KENNEDY VILLA SUBDIVISION

APPLICATION NUMBER 9 DATE October 7, 2010

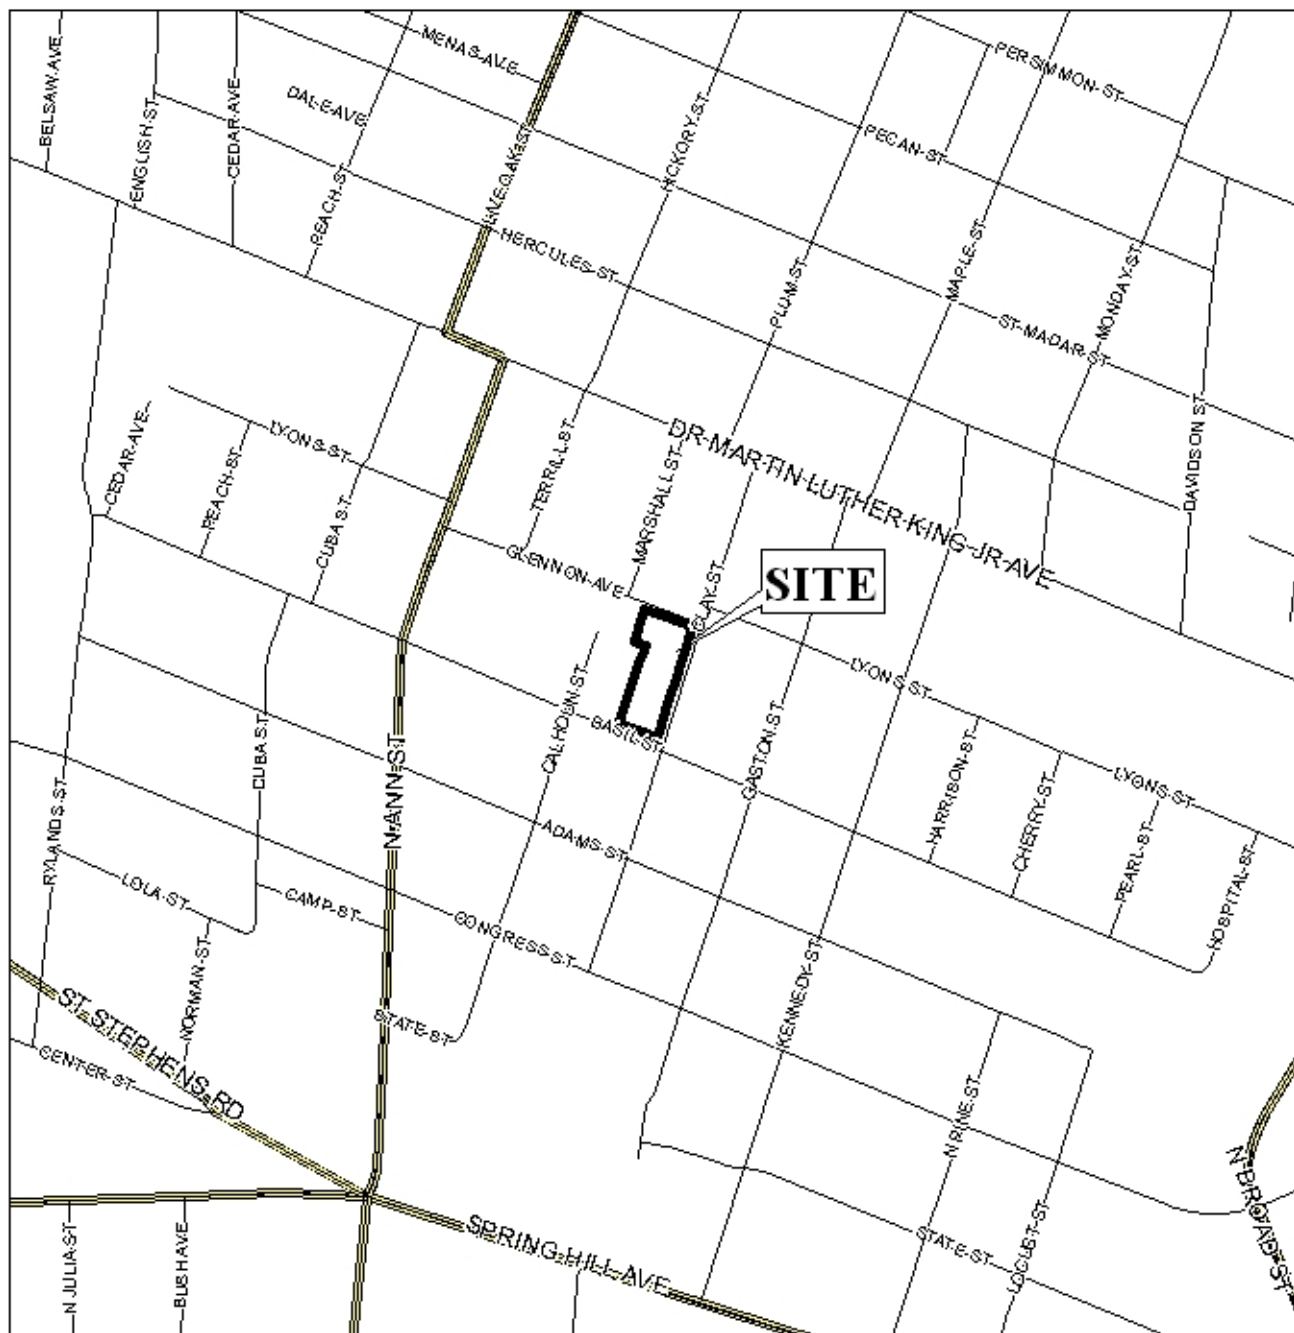
The site fronts onto Glennon Avenue, Clay Street, and Basil Street. Basil Street and Clay Street have compliant 50' rights-of-way and no dedication would be required. Glennon Avenue has a noncompliant 40' right-of-way; however, dedication to provide 25' from the centerline would place the right-of-way line at or within the existing dwelling's front steps. Therefore, no dedication should be required, but the plat should be revised to illustrate a 30' minimum building setback line along Glennon Avenue from the existing right-of-way line. A 25' minimum building setback line should be illustrated along Clay Street and Basil Street as measured from

the existing rights-of-way. Dedication to provide a 25' radius at the corner of Glennon Avenue and Clay Street, and at the corner of Clay Street and Basil Street should be required. As a means of access management, a note should be required on the final plat stating that the lot is limited to one curb cut on Glennon Avenue and one curb cut on Basil Street, with the size, location and design of each curb cut to be approved by Traffic Engineering and conform to AASHTO standards.

The plat should be revised to label the lot with its size in both square feet and acres, after required dedication, or a table should be furnished on the final plat providing the same information.

- 1) revision of the plat to illustrate a 30' minimum building setback line along Glennon Avenue;
- 2) revision of the plat to illustrate a 25' minimum building setback line along Clay Street and Basil Street;

- 3) dedication to provide a 25' corner radius at the intersection of Glennon Avenue and Clay Street;
- 4) dedication to provide a 25' corner radius at the intersection of Clay Street and Basil Street;

- 5) placement of a note on the final plat stating that the lot is limited to one curb cut to Glennon Avenue and one curb cut to Basil Street, with the size, location and design of each curb cut to be approved by Traffic Engineering and conform to AASHTO standards;

- 6) revision of the plat to label the lot with its size in both square feet and acres, or the furnishing of a table on the final plat providing the same information;
